MARKET BUILDING INTERIOR RENOVATIONS

CONTRACT NO. 11220

Addendum No. 2

Electrical Room Photos

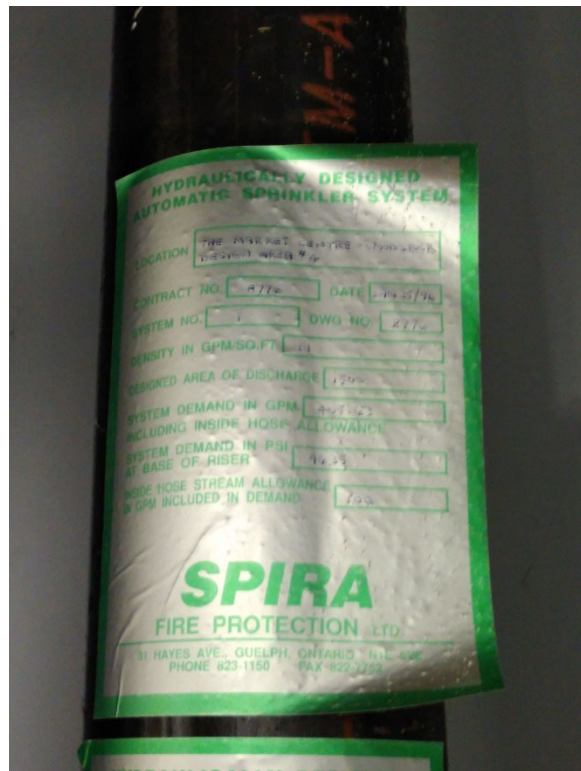
QUESTION 12

ANSWER 12
